# HARTING Product Change Notification

**PCN/23/014/C+N**

**Product range:** Han / Han-Modular

**Title:** Han(R) DD Quad Module new plastic material - External

Photo of present Han® DD Quad module

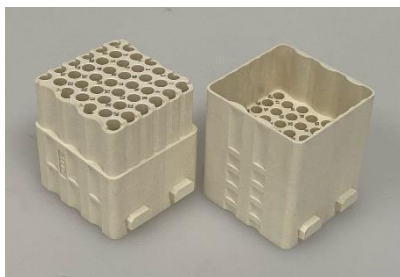
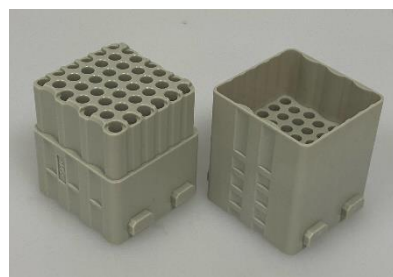
The plastic material of the Han® DD Quad module will be changed from LCP to PC (polycarbonate) which is the same PC that is used for the other Han-Modular® modules.

The change of plastic material has no impact on product specification, handling and application of the DD Quad modules.  
The UL approval of the new module is scheduled for April 2024.
